ENGINE SYSTEMS, INC.

Subject: 10CFR21 Reporting of Defects and Non-Compliance -
Engine Systems, Inc. Report No. 10CFR21-0106, Rev. 0

EMD (Detroit Switch) Temperature Switch – Potential Missing Set Screw

Report No. 10CFR21-0106

TYPICAL EMD/DETROIT TEMP SWITCH
(shown with cover removed)

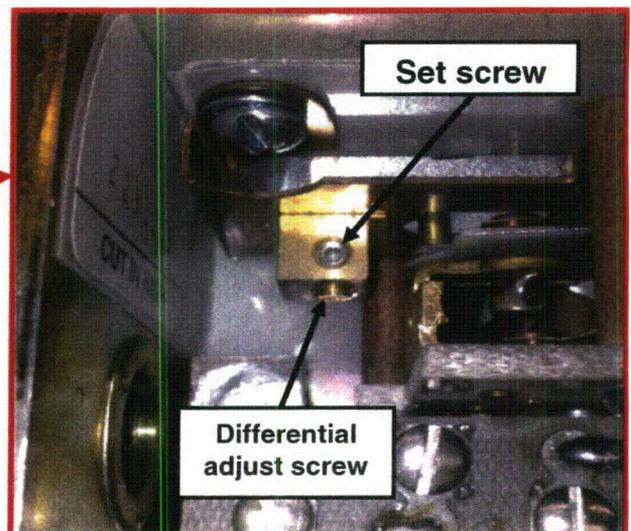
The set screw found in the temperature test fixture oil bath is 1/8" long with #6-32 threads. This is the same length, thread size and style as the set screw used in EMD/Detroit temperature switches to lock the differential adjustment screw.

SET SCREW LOCATION

All affected users should inspect the suspect switches (see Table 1) for presence of the set screw at their earliest convenience. If the set screw is missing, the temperature switch should be returned to ESI for rework.

1. Loosen the screw located in the center of the temperature switch cover.
2. Remove the cover, the mounting screw and cover gasket will remain attached to the cover.
3. Look behind the insulator to access the differential adjust screw.
4. Verify that set screw is installed.
 - a. If installed, re-install the cover; temperature switch is acceptable.
 - b. If not installed, return the temperature switch to ESI for rework.
